**FINDINGS AND RECOMMENDATION
OFFICE OF PLANNING AND ZONING
ANNE ARUNDEL COUNTY, MARYLAND**

CASE NUMBER: 2024-0138-V

REQUEST

The applicants are requesting a variance to allow a new dwelling with less setbacks than required on property located at 1409 Circle Drive in Edgewater.

VARIANCE SITE PLAN

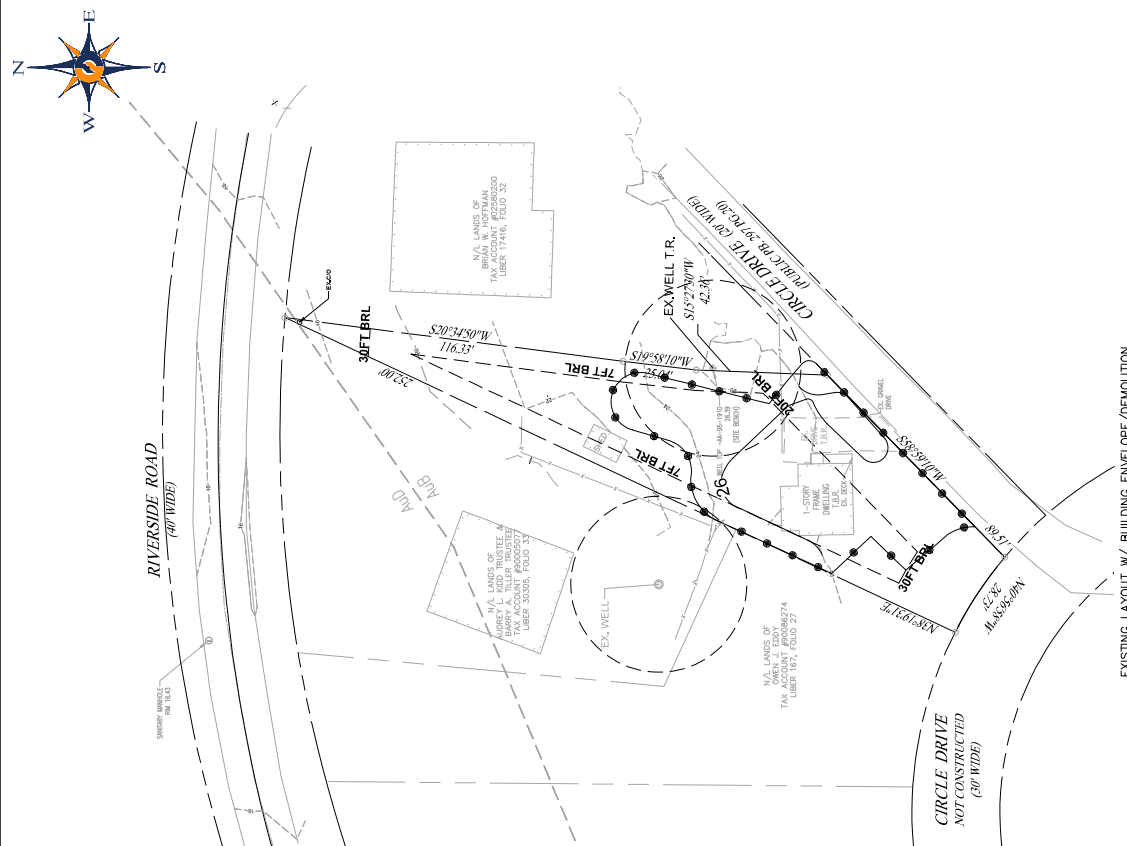
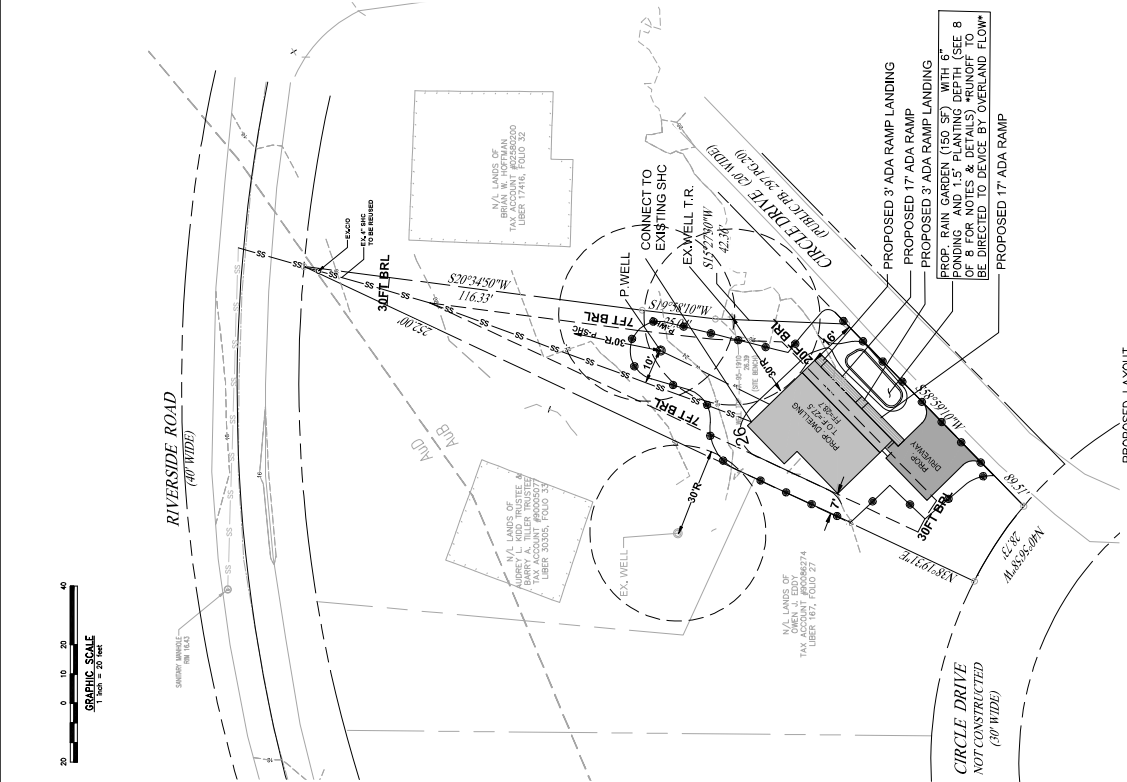
The applicant's letter explains that the site is constrained by existing wells with radii as shown on the site plan and that the irregularity of the site with the setbacks implemented creates a limited buildable area.

1. Stormwater management will be addressed through a rain garden.
2. All stormwater conveyance systems shall be designed so that no building or habitable structure, either proposed or existing, is flooded or has water impounded against it during the 100-year storm event.

3. Please ensure that the rain garden area is setback/offset from property lines so that if it needs maintenance/reconstruction, easements do not need to be obtained from neighboring properties or impact rights-of-way.

4. Microscale stormwater facility(ies) design should incorporate safe conveyance for overflow discharges from 2, 10, 100-yr 24-hr storm events; plans should show overland relief paths for these storm events and ensure that no structures, or properties are negatively impacted or have water impounded against during these storm events.

5. Design professionals should review site runoff and potential (negative, adverse) impacts to neighboring properties, due to changed grades/elevation on a proposed project.

6. Ensure the proposed improvement including runoff, seepage, and slope saturation does not adversely impact the integrity of the slope and potential impact of slope failure.

7. A soil boring is required per practice. The suitability, and siting of proposed SWM practices should be reviewed. Soil boring information including verification of the suitability of in-situ

soils for infiltration shall be submitted. Describe the site's hydrologic, and topographic characteristics and provide a recommendation on the feasibility of various BMPs.

8. Based on the plan provided, it appears that the property will be served by a private well and a public sewer.

10. Based on the above comments and proposed site design, this office does not support this request.
